CITY OF WOODLAND
300 FIRST STREET
WOODLAND, CA 95695

65% SUBMITTAL

SPORTS PARK DR. POC
FOUNDATION PLAN

**SPORTS PARK DR. POC
ABUTMENT DETAILS**

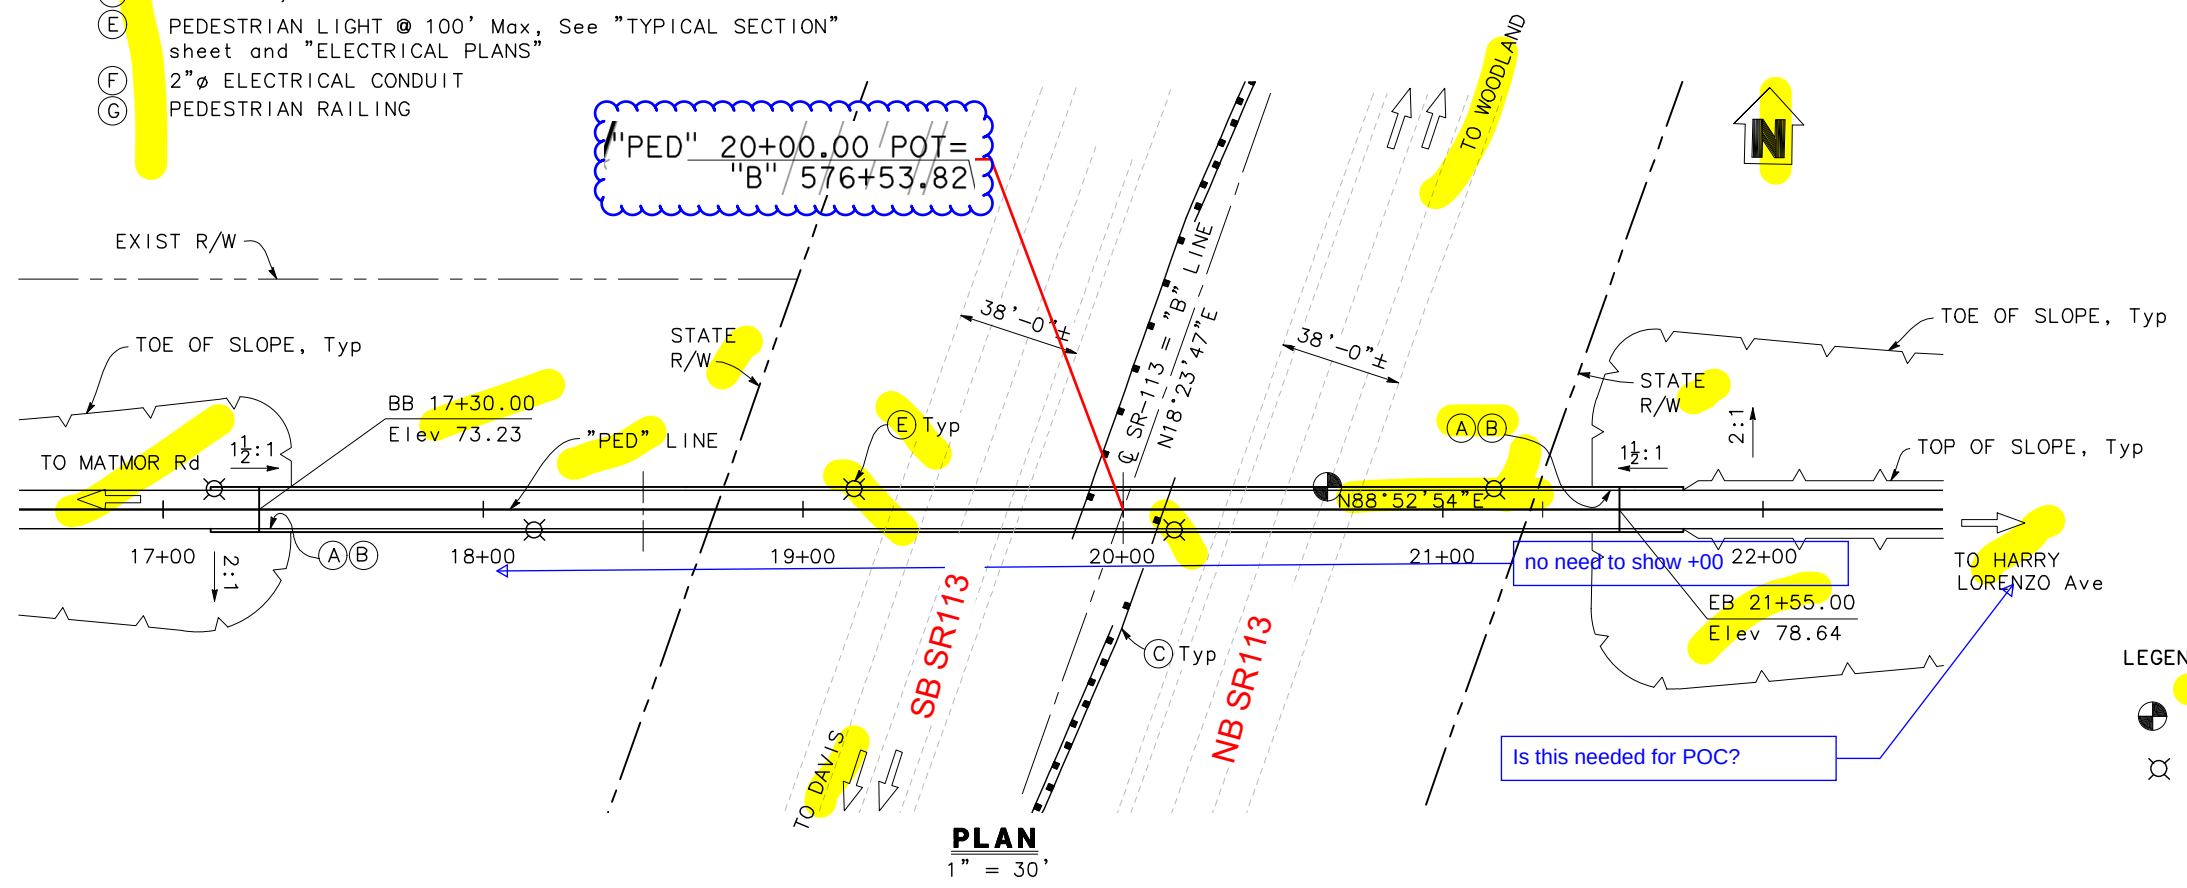
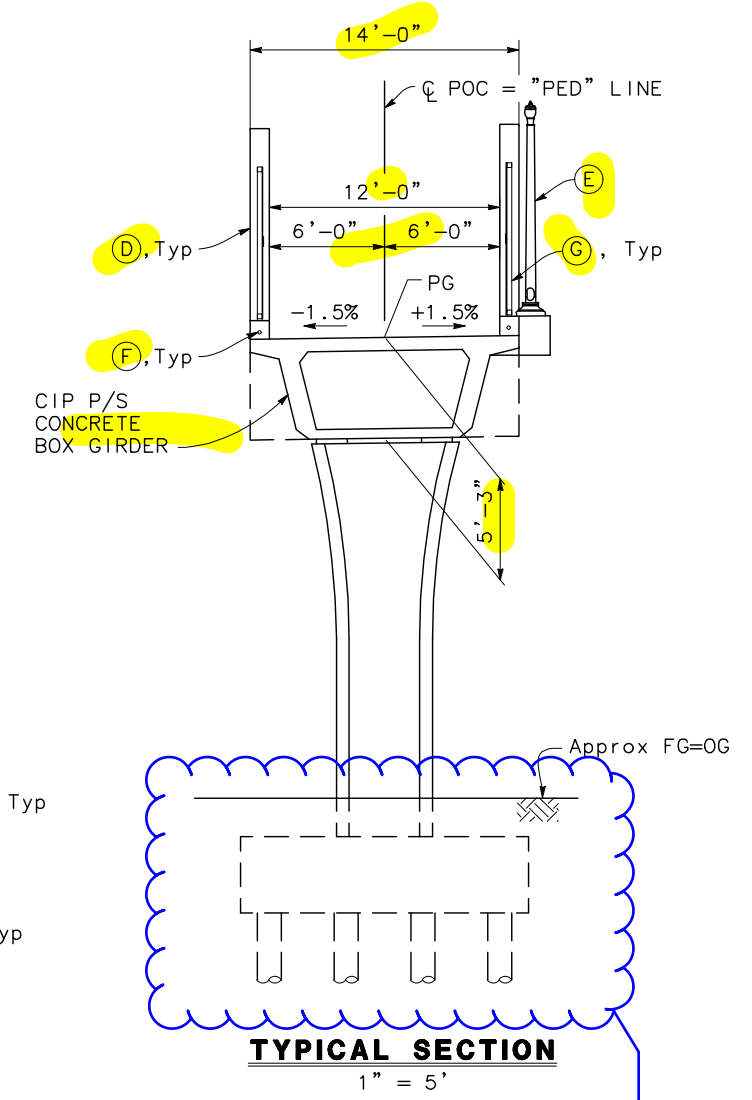
Update

PILE LAYOUT
1/4" = 1'-0"

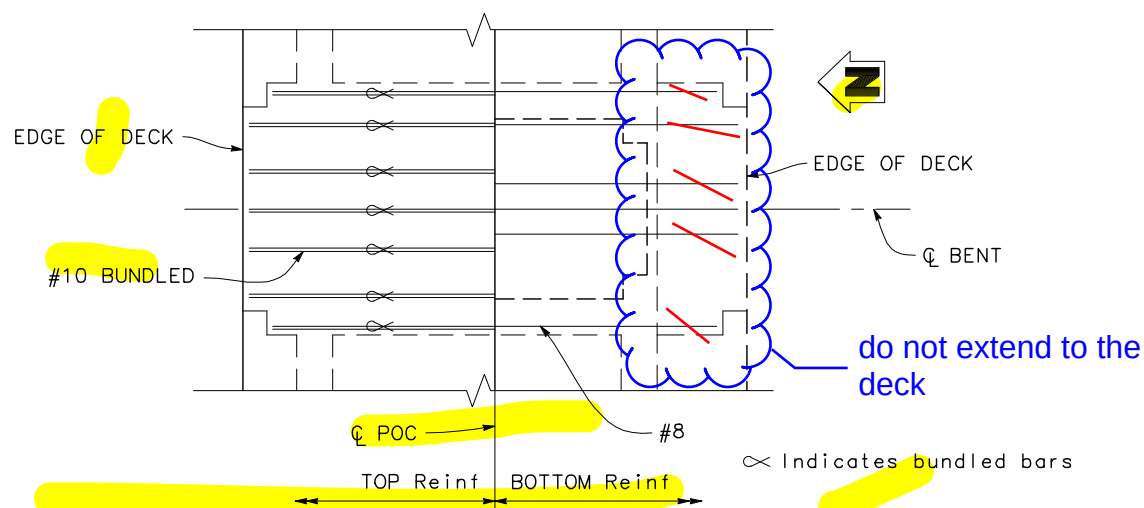
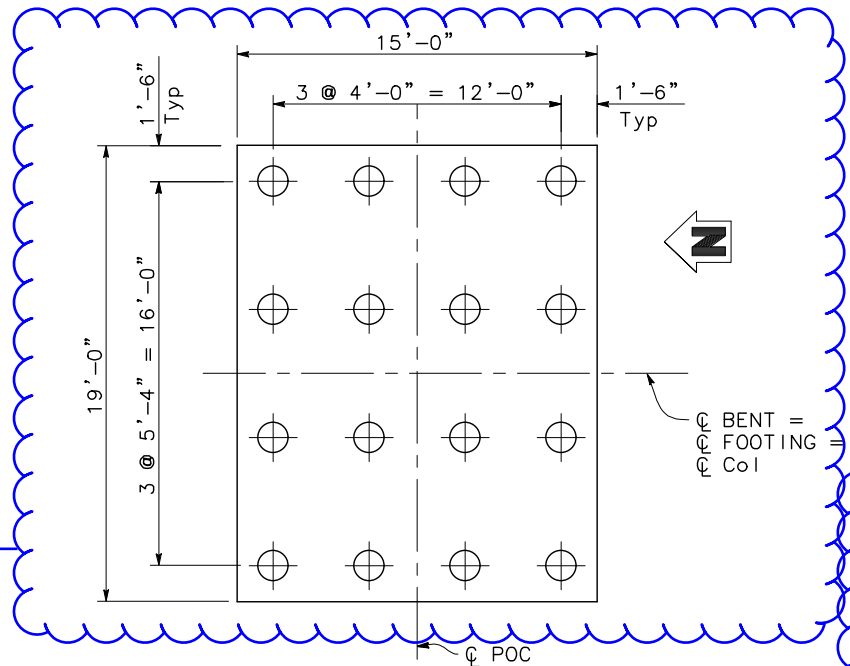
update

PILE DETAILS CLASS 200 (Mod)
1" = 1'-0"

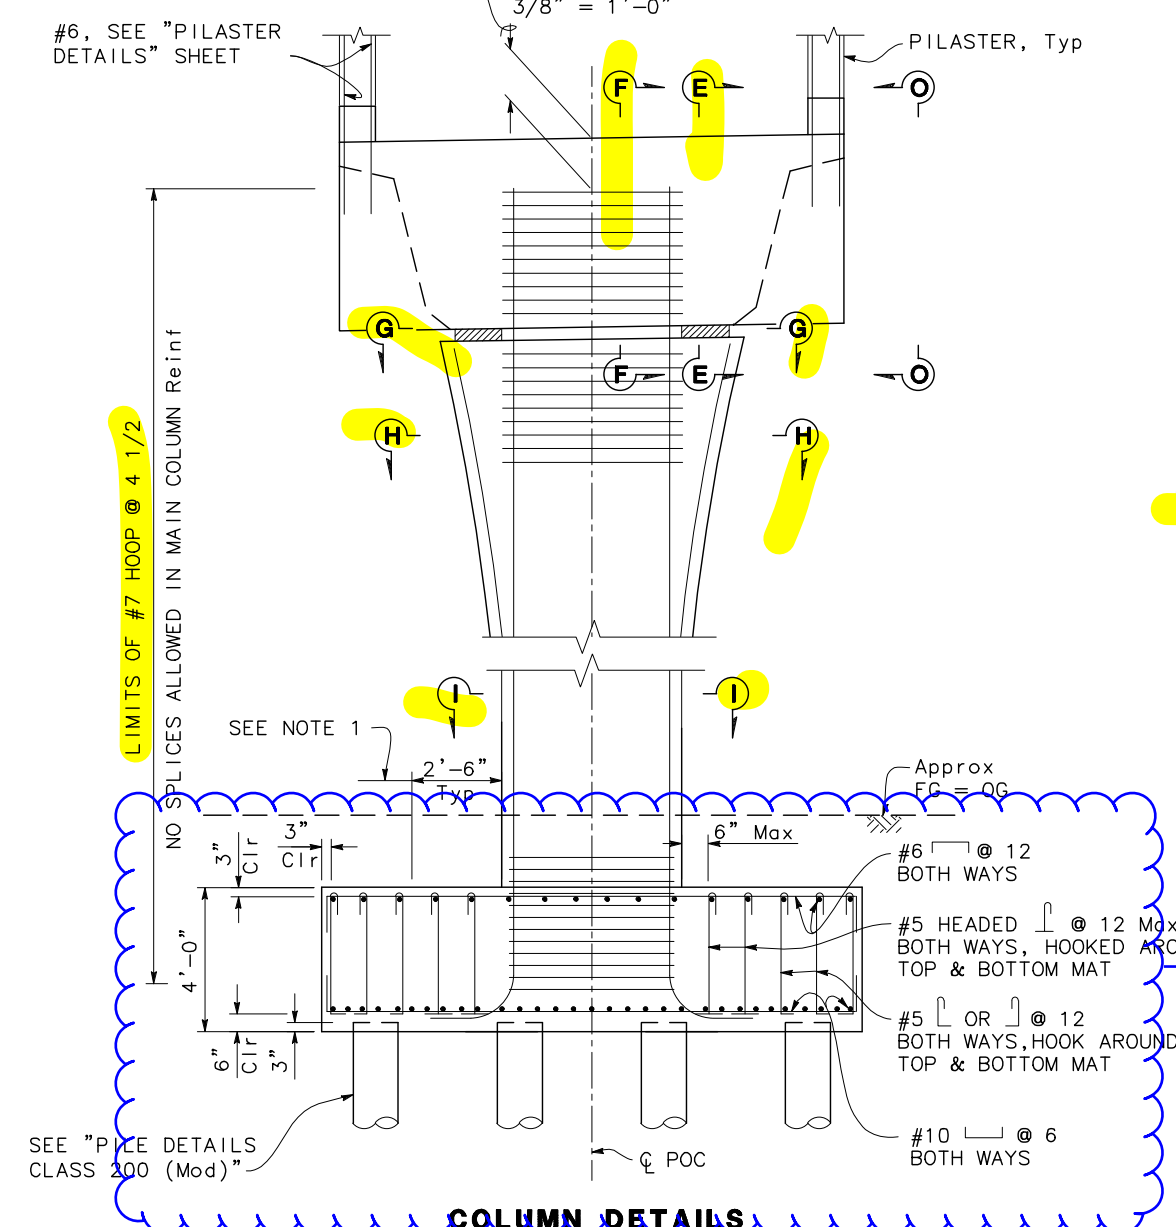
update

COLUMN FLARE DETAIL
1/4" = 1'-0"

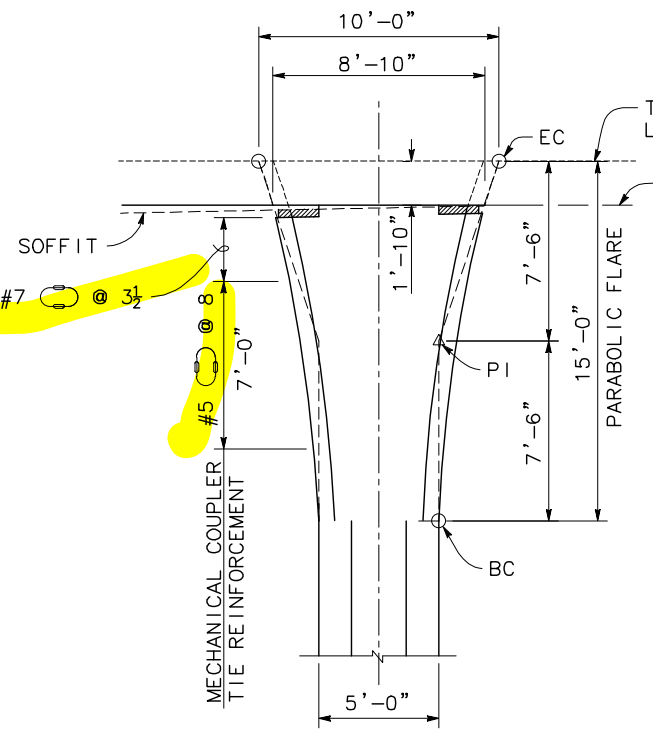
Update

PRESTRESSING NOTES

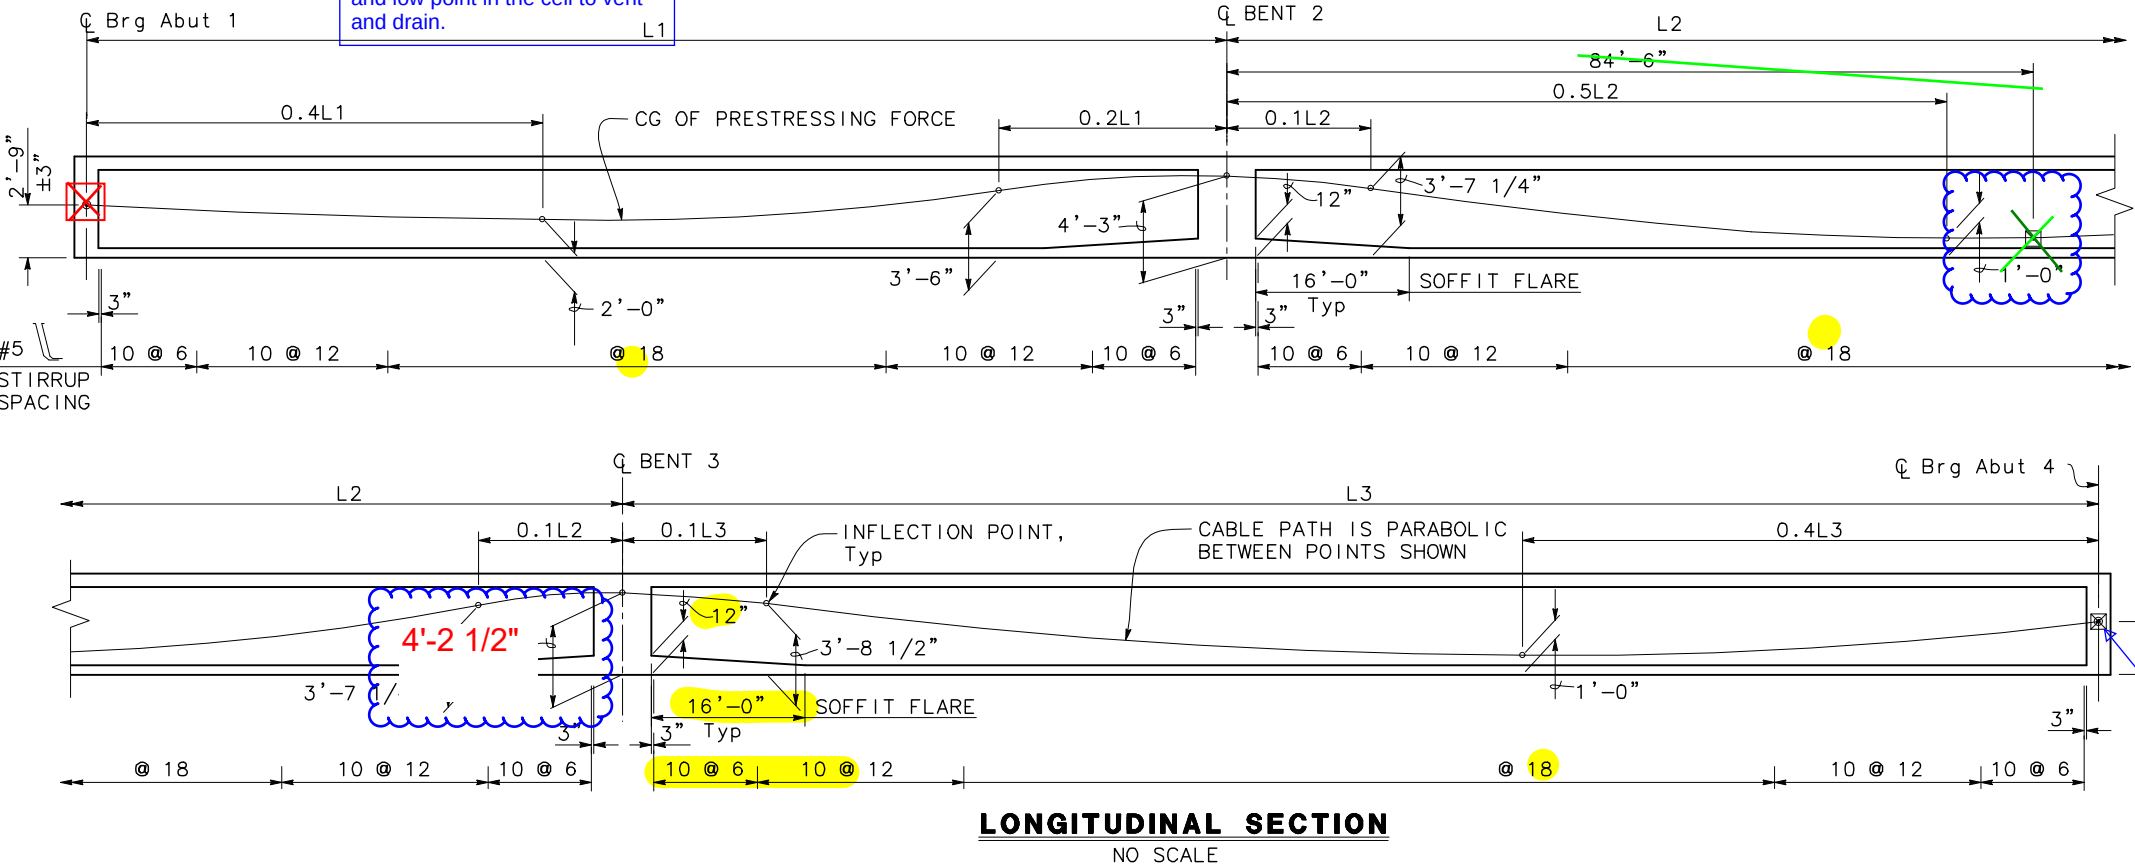
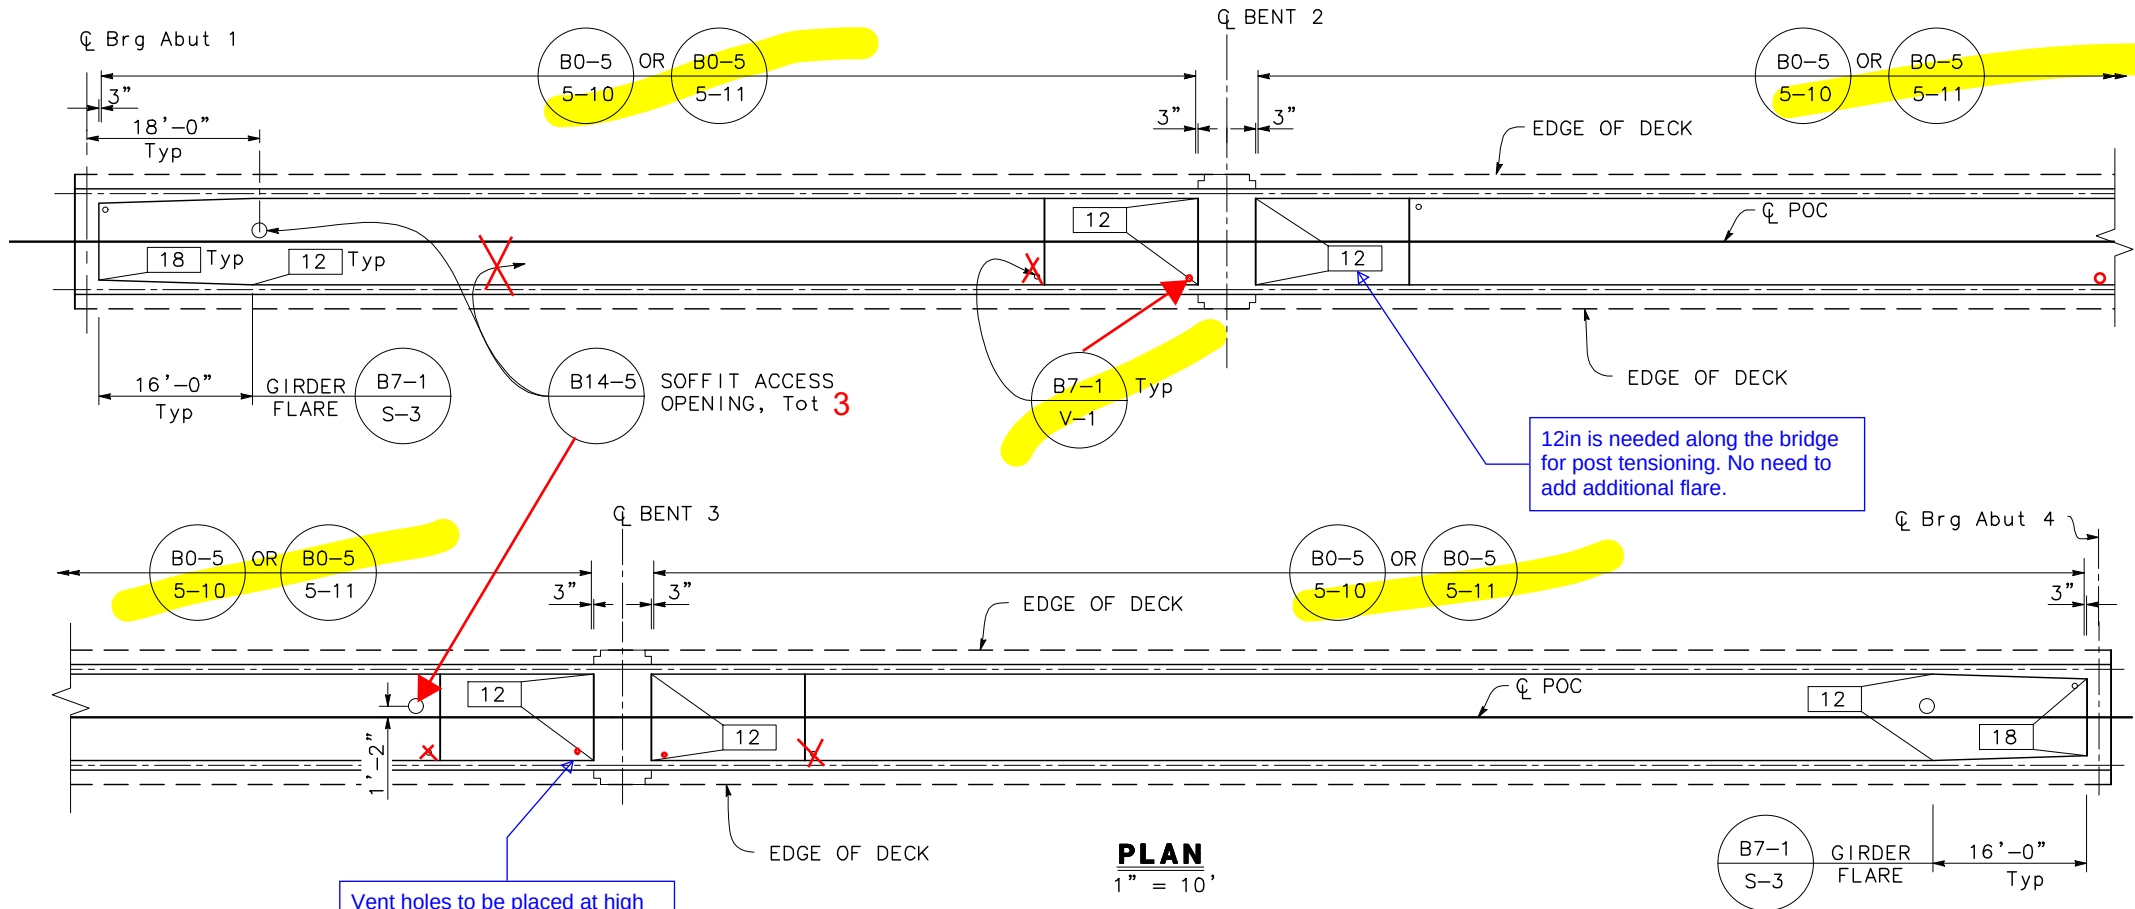
show circle at abutment 4, square at abutment 1 for one end stressing
